Subject: WPX RDU 12 - additional lab report **Attachments:** 17031099 (WPX) RDU 12 Final Report.pdf

Subject: RE: [EXTERNAL] RE: WPX RDU 12 - initial spill notification

RE: WPX Energy * RDU 12 * 30-015-24793 * 2RP-4095

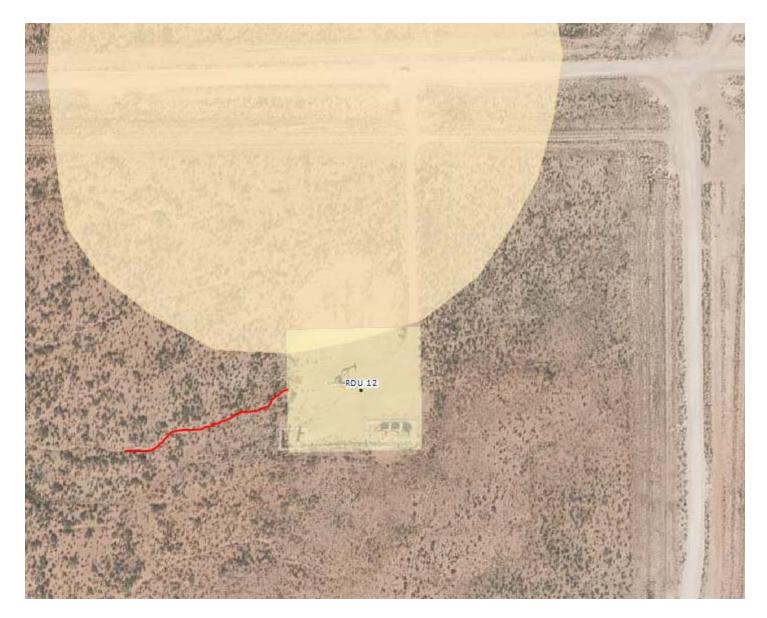
I received the lab results for samples collected from the dry ditch located west of the RDU 12 pad – please see the attached lab report and sample location map.

It appears that the samples collected from the drainage are below OCD's cleanup standards for hydrocarbons (Ranking score is 0) and since there is no cleanup standards for salts, I'll let OCD decide if the drainage is clean enough. The sample collected on the well pad has elevated chloride concentrations and the impacts will be further delineated.

Please let me know if the drainage meets BLM's and OCD's cleanup standards; the drainage will not be re-contoured until the remediation activities are completed.
